Nationally Significant Infrastructure Project EN01027: Mallard Pass Solar Farm

Local Impact Report - June 2023

Appendix A – Comments from LCC appointed landscape consultants (AAH)

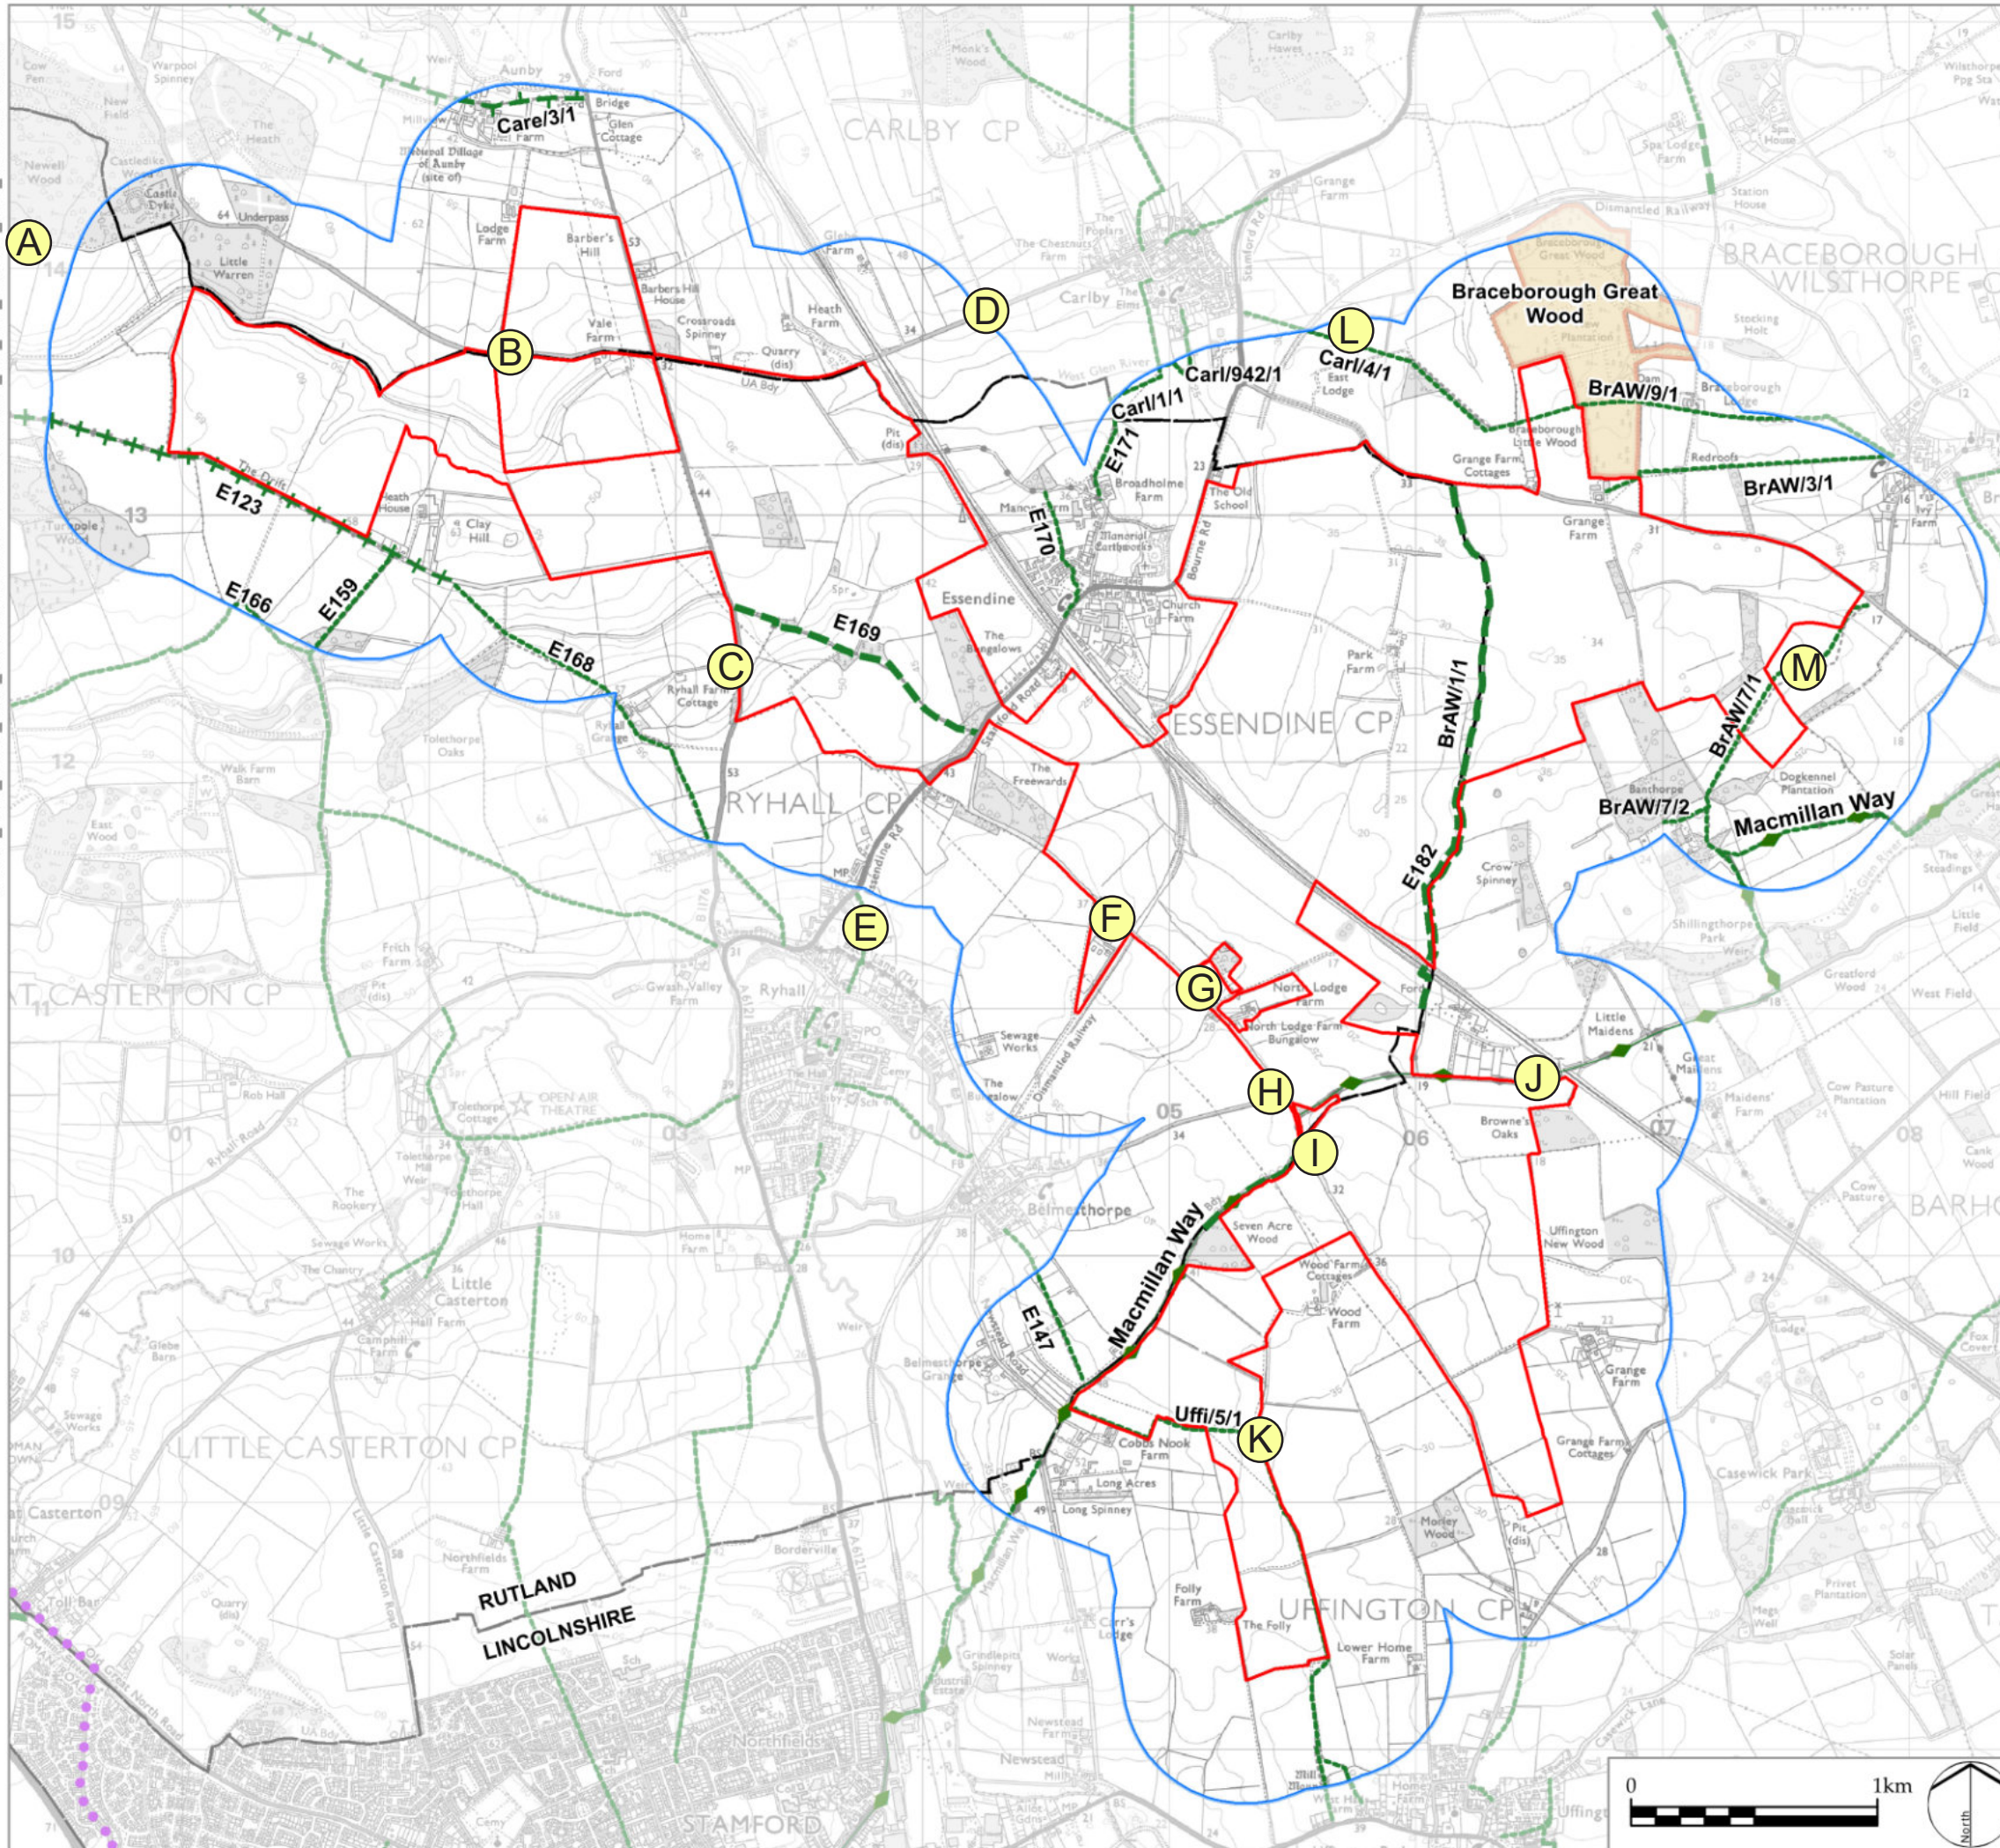
The following comments are in regards to visibility of the site from specific receptors and viewpoints, and the plan attached to this memo should be referred to for these target notes, which we would suggest are discussed at a further workshop prior to finalising. All photography should provide the most advantageous views of the site and proposed development:

- A. **Additional viewpoint included from the lane south of Newell Wood.** There are likely views from a high point along this road, approximately at the location of a small pull in/lay-by, that allows views east and south east to the western area of the site;

- B. **Additional viewpoints included from the lane between Newell Wood and Vale farm.** There are several gaps in the carriageway vegetation allowing clear views north into the site, and potentially southern views, however these would be across an open field (not within the site redline) to the development;
